JUST CROSSING ALLIANCE

Active Transportation and Transit Vision

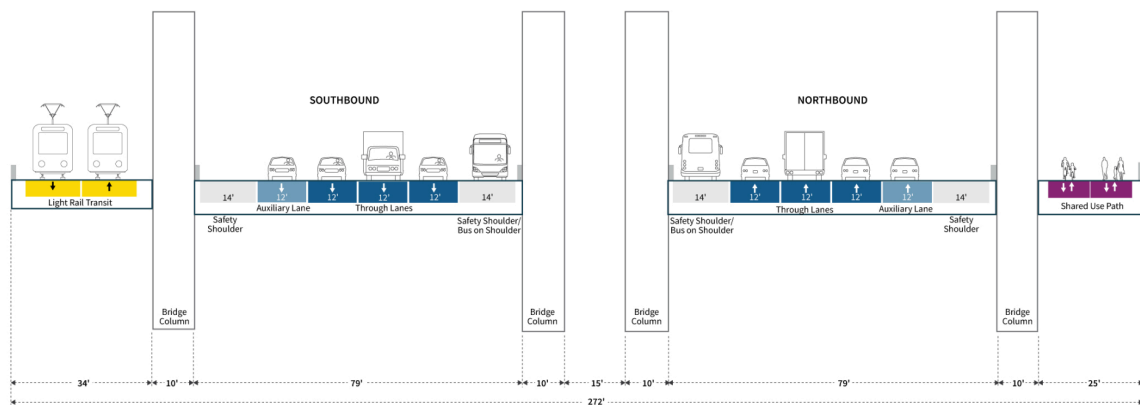
Currently the Modified Locally Preferred Alternative (MLPA), as documented in the diagram below from the DSEIS, allocates 158 feet to motor vehicle capacity, the lowest throughput opportunity, and only 59 feet to transit and active transportation. We don't consider bus-on-shoulder to be an allocation of space, only a borrowing of space from mixed traffic operations.

Ensuring that there are options to reallocate this space to higher throughput uses of transit and active transportation in the future is vital to a responsibly designed project for a climate-resilient future.

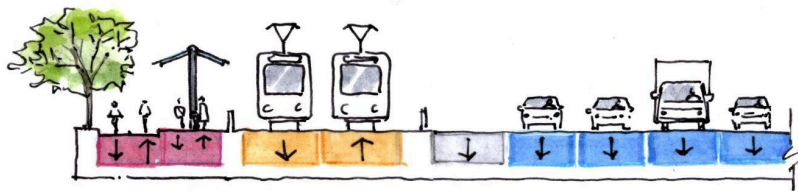
The project configuration proposed in the Draft SEIS places active transportation on one edge of the project and transit on the opposite edge of an adjoining structure (or in the two level configuration, underneath separate structures).

We share a view with the Active Transportation Working Group that for numerous reasons, these two modes should be adjacent to each other. Some of these reasons include:

- Users should be able to transition from active transportation to transit or vice versa at any of the transit stations within no more than a few steps (and no grade changes).

- Active transportation users should have elevator access at elevated egress points. Making use of the transit station elevators removes the need for multiple sets of elevators.

- Transit operators and passengers will serve as “eyes on the path” countering a sensation of isolation and increasing the user security and comfort of the multi-use path.

- The multi-use path can serve as emergency egress for the transit way.
- Inclusive design principles should be employed to make sure that the transit and active transportation components are as accessible as possible.

Furthermore, if a single-level configuration is selected, the multi-use path should be on the outside of one of the structures, next to the transit way which will serve as a buffer from noise, vibration and debris from the motor vehicle lanes.
